DEVIATION REQUEST AND DECISION FORM

Project Name : Crossroads Mixed Use Filing No. 2 at Meadowbrook Final Plan

SD 4-4 Urban Residential Collector:

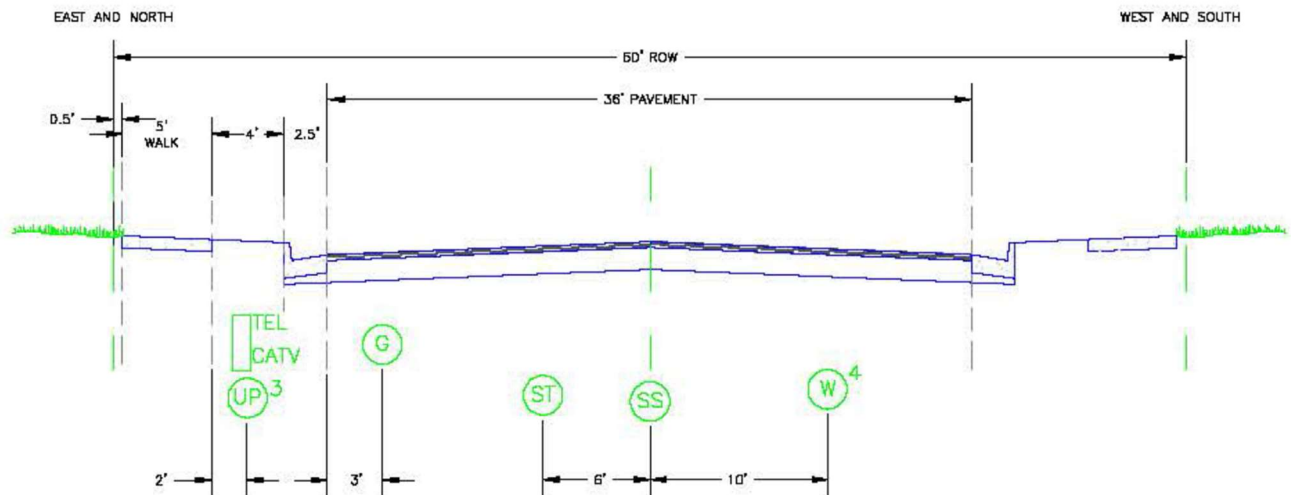
A deviation from the standard Urban Residential Collector Roadway Cross Section for Southern Rail Point, Pacific Rail Point, and Central Rail Point is requested. The standard cross section includes two travel lanes (12') and two shoulders (6') within a 36-foot wide pavement mat; two 2.5-foot curb and gutter at the end of the pavement mat; two four (4) foot (typical) landscape/tree lawns; two five (5) foot detached sidewalks all within a 60-foot ROW.

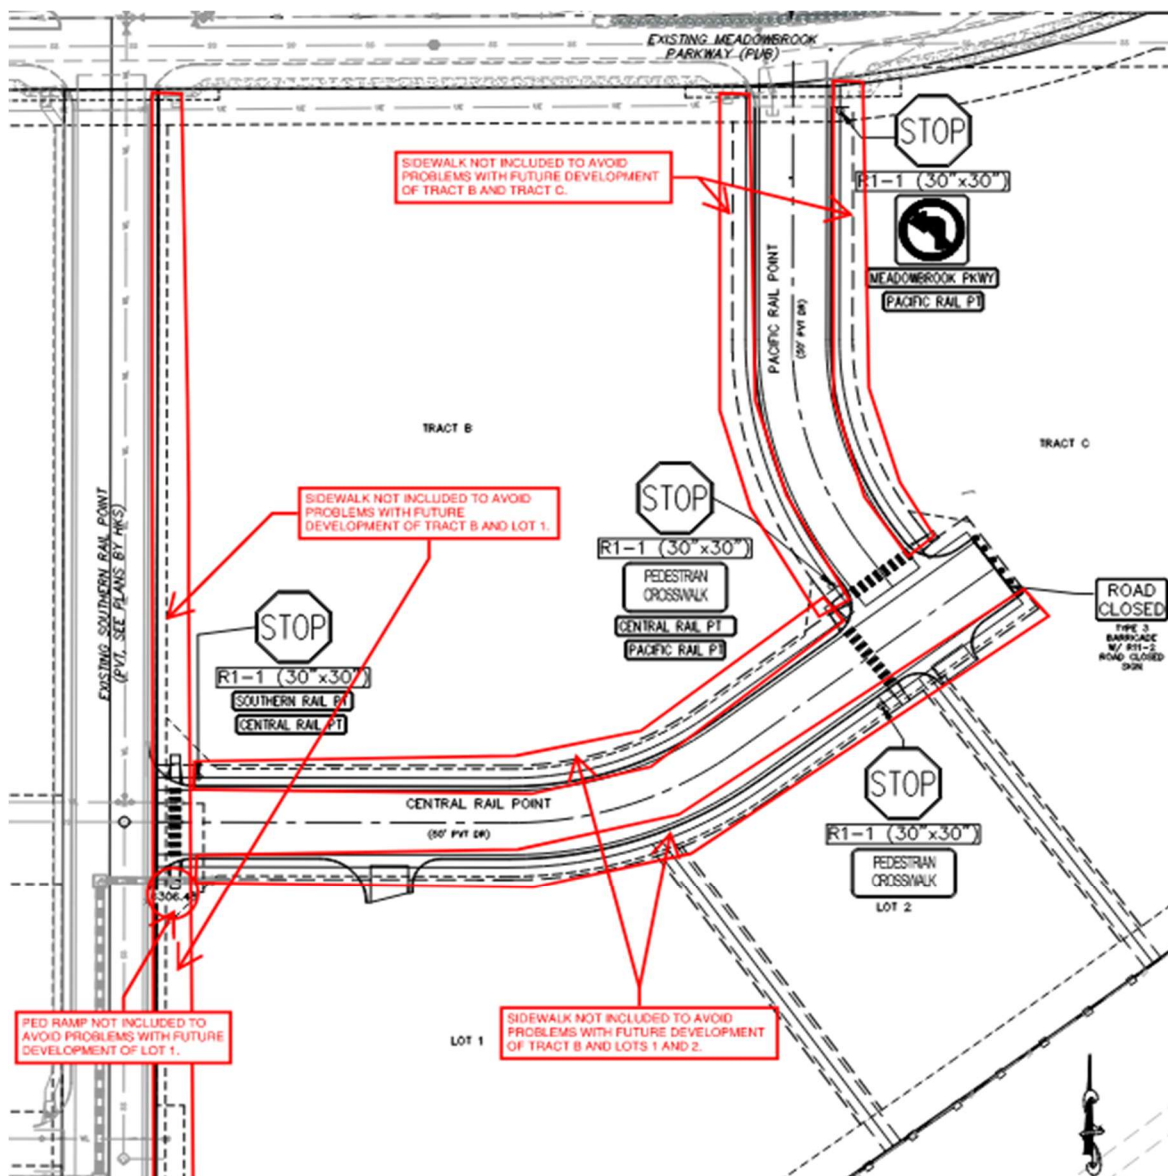
The proposed private road cross section includes the following deviation(s) from standard ECM Standards for an urban residential collector section. Requesting;

- 50-foot tract dedicated for private road and utility use. Typical cross section is within a 60-foot Public ROW.
- 36 foot pavement width, where typical cross section has a 36' pavement width. No Change.

- Two 12-foot travel lanes with two 6' shoulders, where typical cross section has two 12-foot travel lanes with two 6' shoulders. No Change.
- 40 MPH design speed/35 MPH posted speed, where typical cross section has 40 MPH design speed/35 MPH posted speed. No Change.

- 5-foot detached sidewalk on one side, where typical cross section has 5' detached sidewalks on both sides. The sidewalk is outside of the 50-foot tract. An additional 5 foot Public Access Utility Easement has been provided to accommodate the portion of sidewalk lying outside the tract. Only one side of the roadways are proposed to have an attached sidewalk. Several sidewalks and ADA Ped Ramps are not proposed with Filing No. 2 in the specified areas (outlined in red) because they may cause problems with future development and driveway cuts.
